STAFF RECOMMENDATION
144 Windsor Drive
September 19, 2012

Application: Appeal
District: Belle Meade Links Triangle Neighborhood Conservation Zoning Overlay
Council District: 23
Map and Parcel Number: 13001008600
Applicant: Jackie Daniel, owner
Project Lead: Robin Zeigler, robin.zeigler@nashville.gov

<p>Description of Project: The applicant installed a front window that is different than the one permitted.</p> <p>Recommendation Summary: Staff recommends disapproval as the window is different than that permitted by the MHZC and has an industrial design which is inappropriate for a residential district.</p>	<p>Attachments A: Photographs B: Permit</p>
--	--

PROPOSED FRONT ELEVATION

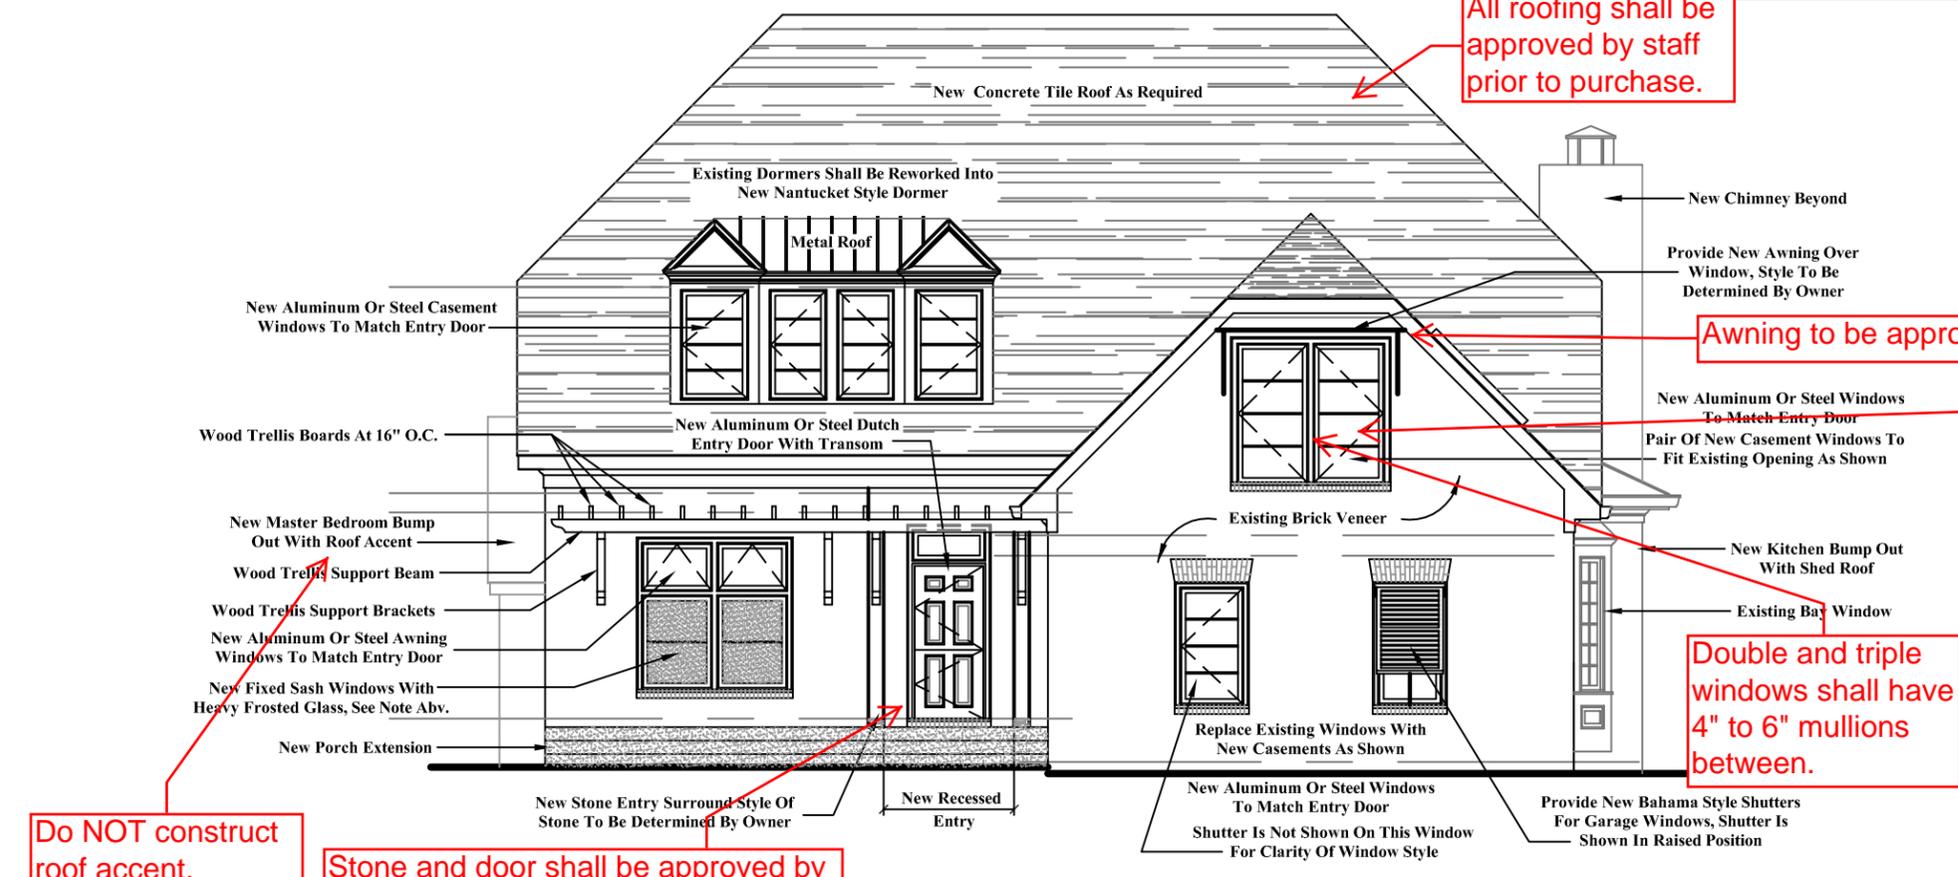
On a routine inspection on July 31, 2012, staff noticed that the windows that had been installed were not trimmed as shown on plans and the center front dormer window did not match the plans. Staff found the center window to be industrial in design, the proportions not in keeping with historic windows, and that the new window did not meet design guideline II.B.1.d and g as the details of the new window were not visually compatible with the rhythm of openings of surrounding historic buildings. Staff requested the applicant remove the window and install the windows as shown on plans. After discussions, the applicant chose to appeal staff's decision to the Commission.
